PLANNING, ZONING, & BUILDING DEPARTMENT  
PZ&B Staff Combination Memorandum: Architectural Commission and Town Council

SUBJECT: ZON-23-077 (ARC-23-107) 162 E INLET DR (COMBO)

MEETING: NOVEMBER 20, 2023 ARCOM  
DECEMBER 13, 2023 TC

**November Rear Elevation**

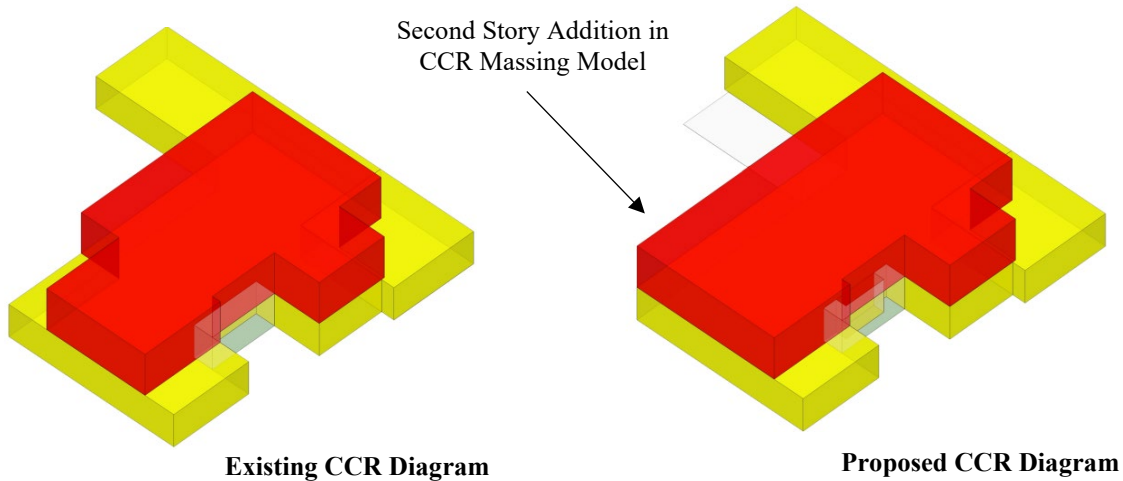
Modifications are also proposed to the second story rear addition. The applicant is now requesting to utilize a new parapet roof configuration which applies barrel tile slopes to the south and east sides in order to help integrate the addition into the primary roofline.

Additionally, engaged columns have been added to the rear (south) and side (east) elevations of the addition to help create the appearance of a covered terrace, or sleeping porch, that has been enclosed over time. The bracketed trellis over the rear doors has also been removed from the design.
